Product Change Notice (PCN)

Subject: Carrier Tape change for Renesas Product ISL91108* WLCSP Packaged Product

Carrier Tape dimension change for Renesas Product ISL91108* WLCSP Packaged Product

Appendix A- Comparison of Carrier Tape Dimension

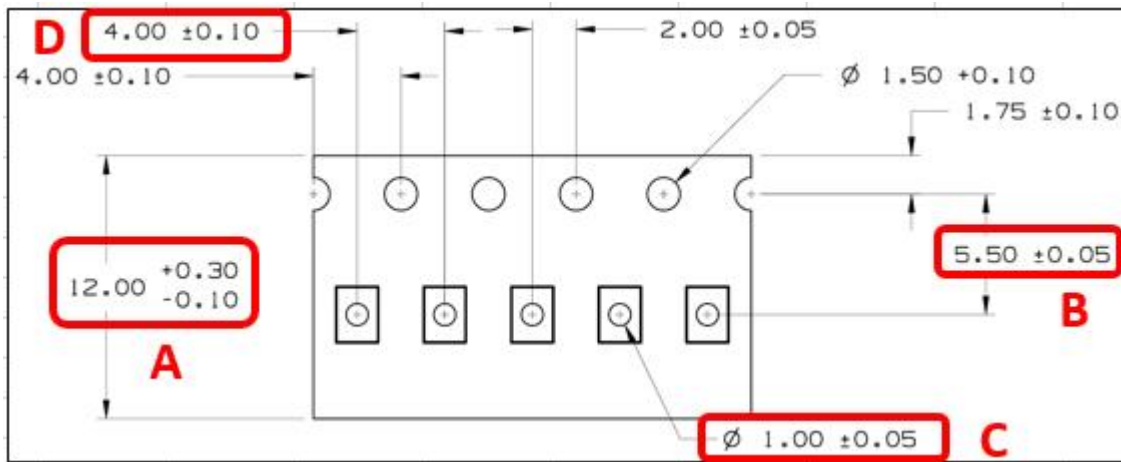
1. Lokreel width comparison table was removed. Because the carrier tape width will maintain as 12mm, therefore there is no change to the lokreel width.
2. The new carrier tape width (Code "A" as shown in Appendix A) will maintain as 12mm (no change)
3. The corresponding pocket dimension were revised as outlined in Appendix B.

#	Code	Dimension	Existing Carrier Tape	New Carrier Tape	Summary
1	A	Carrier Tape Width	12.00 mm + 0.30 mm - 0.10 mm	12.00 mm + 0.30 mm - 0.10 mm	No change
2	B	Index Hole to Pocket Hole Width	5.50 mm ± 0.05 mm	5.50 mm ± 0.05 mm	No change
3	C	Pocket Hole Diameter	1.00 mm ± 0.05 mm	1.00 mm ± 0.05 mm	No change
4	D	Carrier Tape Indexing pitch	4.00 mm ± 0.10 mm	4.00 mm ± 0.10 mm	No change

Appendix B – Comparison of Carrier Tape Dimension (Cont')

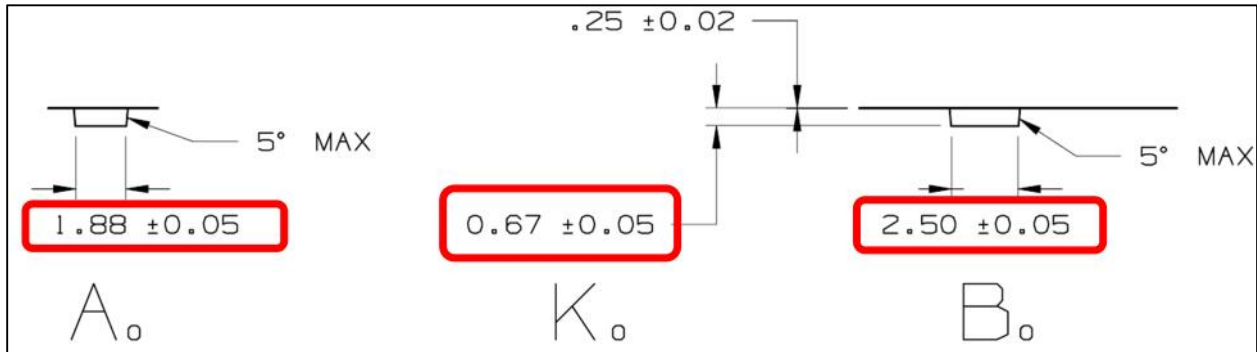
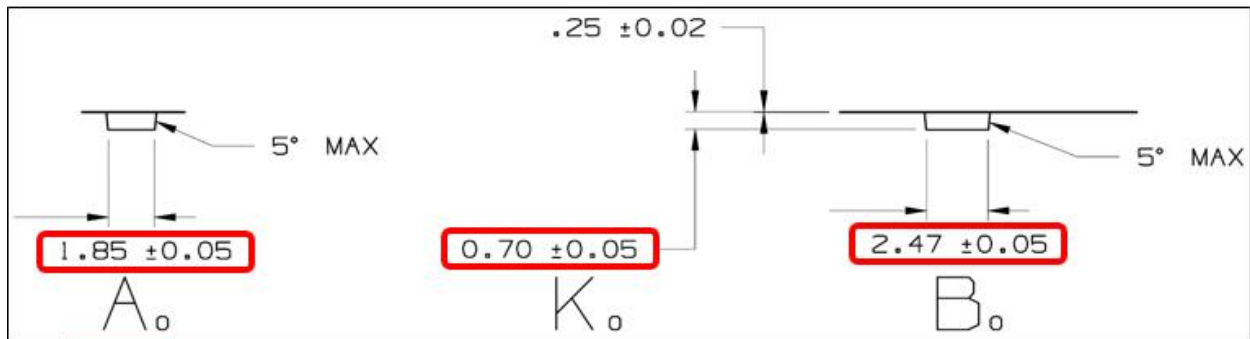
#	Code	Dimension	Existing Carrier Tape	New Carrier Tape	Summary
1	A_0	Pocket Width	1.88 mm \pm 0.05 mm	1.85 mm \pm 0.05 mm	Change
2	K_0	Pocket Depth	0.67 mm \pm 0.05 mm	0.70 mm \pm 0.05 mm	Change
3	B_0	Pocket Length	2.50 mm \pm 0.05 mm	2.47 mm \pm 0.05 mm	Change
